The Tree Consultancy Company

Memo

To: Burnette O'Connor – The Planning Collective
From: Sean McBride – Director, The Tree Consultancy Company
cc:
Date: 13 August 2021
Re: 1092 Coatesville Riverhead Highway,
Proposed retirement village

See Drawing 2098 002 B

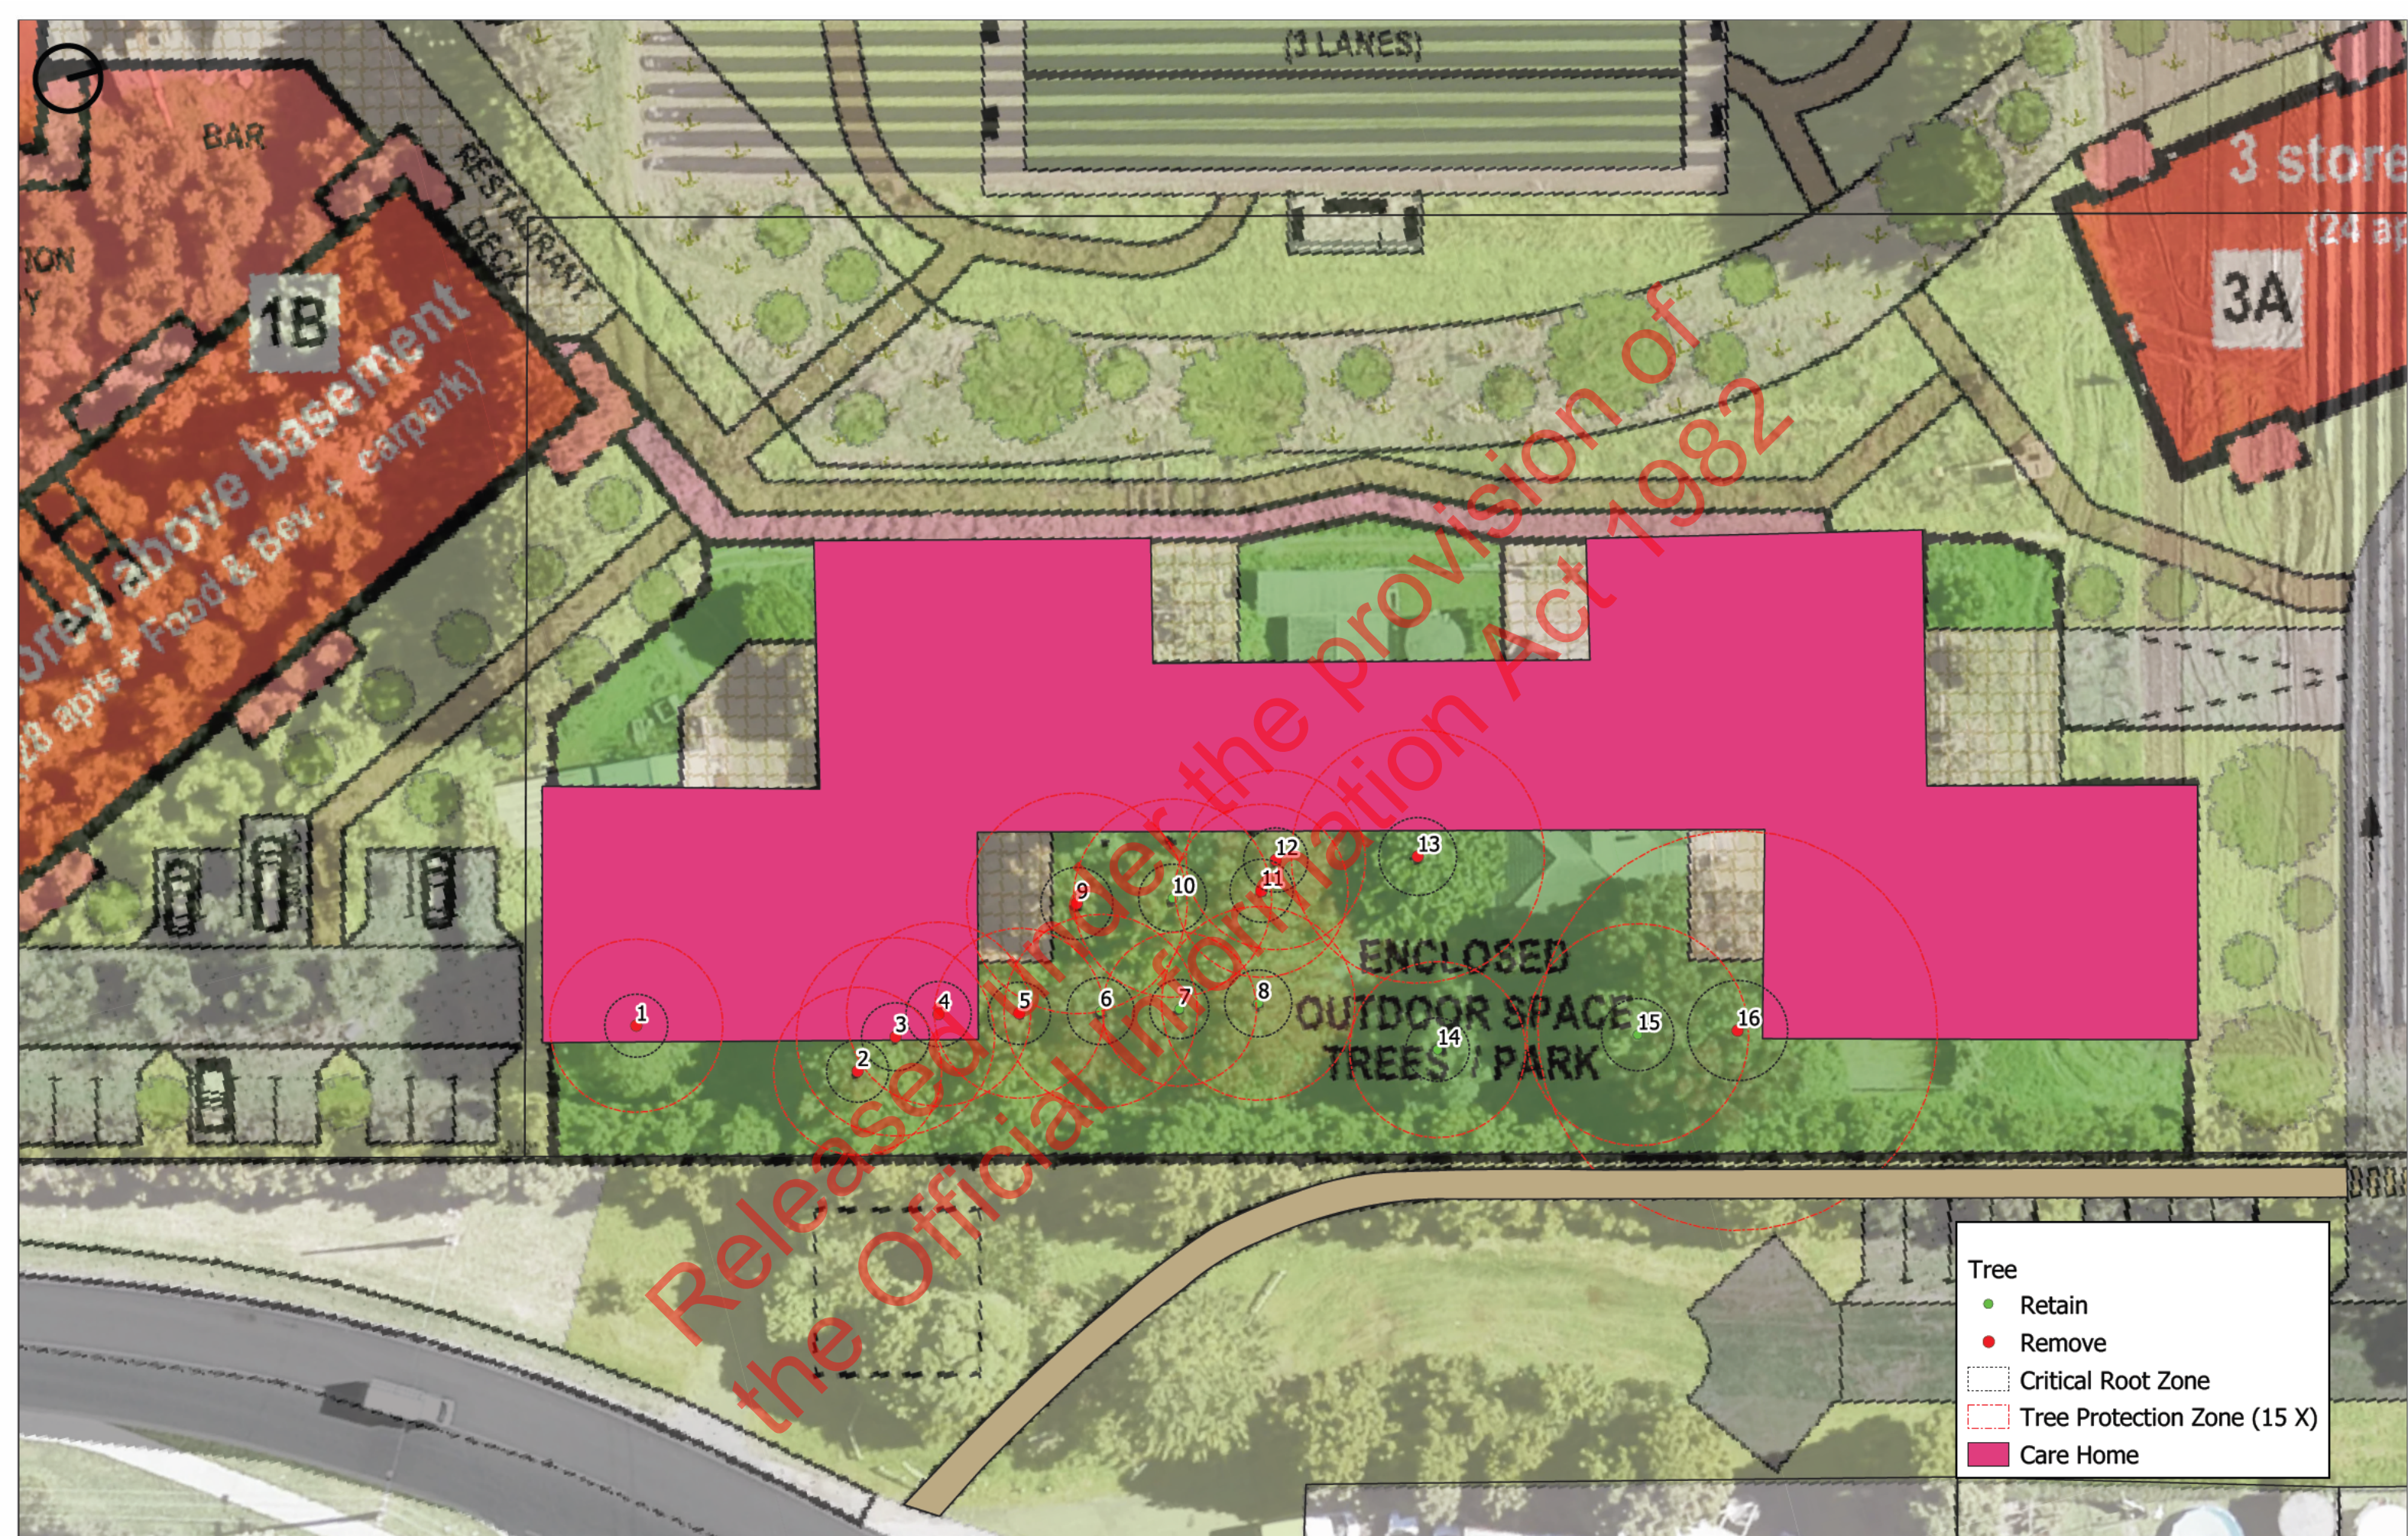
- 3.3 Two other unprotected mature trees adjacent to the existing dwelling also have the potential to be retained and incorporated into the development, an olive and another five American sweetgums (Trees 6, 7, 8, 10 and 14). Some pruning to improve the scaffold branch form of one the American sweetgum is recommended to address tree risk features. The six retained trees have been incorporated into an enclosed outdoor space/park, with sufficient space to enable their development into full maturity.

- 4.2 The development layout has been designed to allow for the retention of six non-protected trees, providing sufficient space for them to develop to full maturity. The shelterbelt trees are arboriculturally unremarkable and removal of these trees is a permitted activity under the Unitary Plan rules. A prescriptive number of new trees can be provided to ensure there is no deficit of ecosystem services that the trees offer over a set period of time (usually 2050, as this is when New Zealand is required to be carbon neutral).
